CITY OF PORTLAND BUILDING PERMIT

Job ID: 2011-09-2206-NEWCOM

Application Number: 2011-168 **Application Date:** 1/18/2011 12:00:00 AM
Project Name: International Marine Terminal Improvements
Address: 468 Commercial Street
Project Description: Removal of existing bld., pier expansion, new office bld.
Zoning:
Other Reviews Required: Level III, Stormwater Management *in conformance with*
Review Type: *043-D-5*

RE: International Marine Terminal Improvements Project – RFI #11 Response

INTERIOR WINDOWS

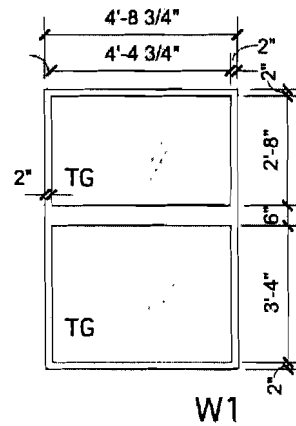
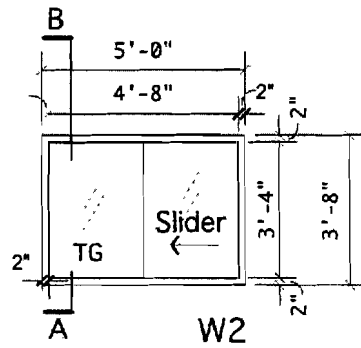
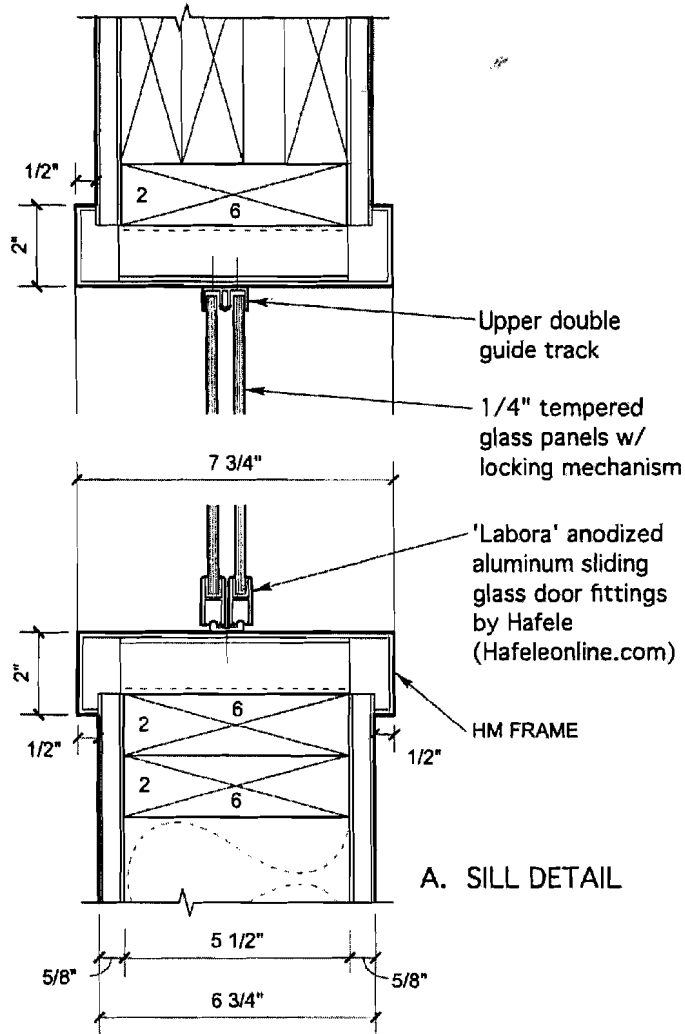
Question: On Sheet A.A1, the Security Office has a type W1 and type W2 window. These windows are not shown on the window schedule or the door and frame schedule. Please clarify.

Response: Interior windows "W1" and "W2" are shown on the Ground Floor Plan on Sheet A.A1 and on interior elevations A/A.A12, 4/A.A13, and 1/A.A13 but they do not appear on the door and frame schedule on Sheet A.A9.

SHELF AND HOOK DETAIL AT ENTRY 107

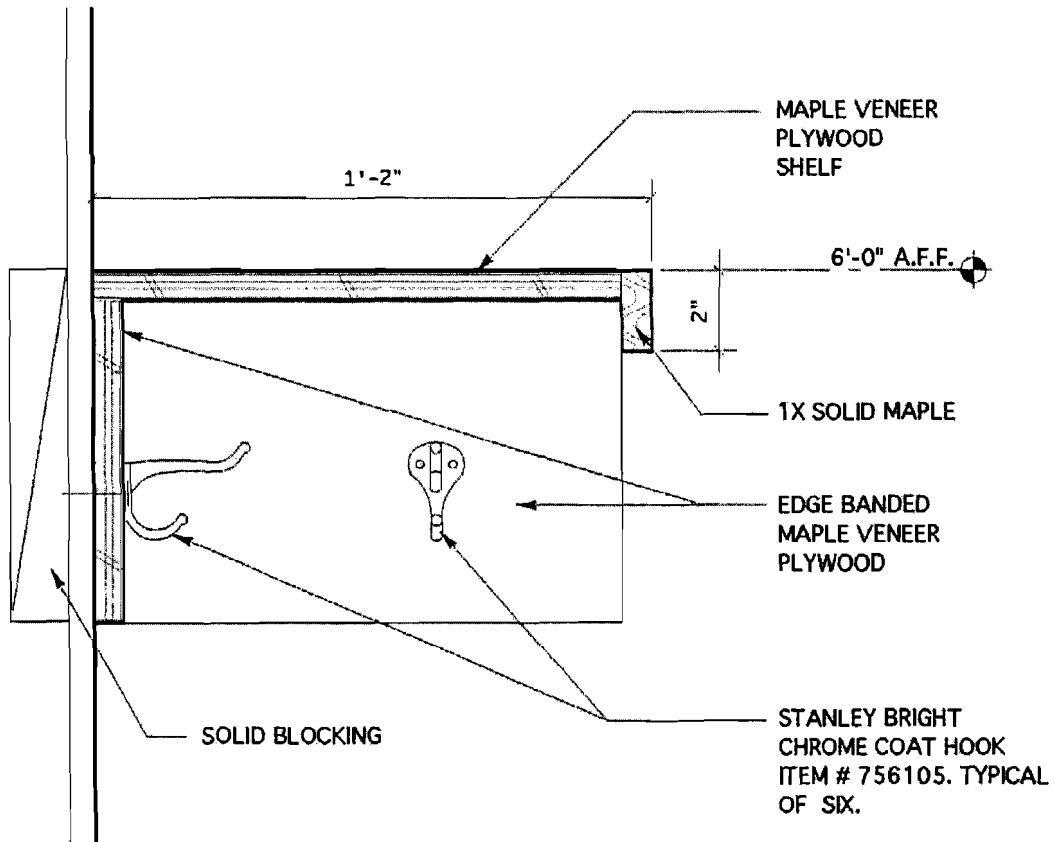
Question: Reference drawing A.A1 in room 107 "Entry" – there are several items shown on the walls (North and West), what is indicated? These items are also shown on the interior elevation 2-2 and 2b on Plan Sheet A.A12.

Response: The items shown on the interior elevations of entry 107 are a built-in bench and a built-in overhead with coat hooks. The bench is described in Detail 4 on Sheet A.A10 and the clear finished wood referenced in the notes refers to maple. A detail of the shelf was not provided. See attached sketch for shelf detail.
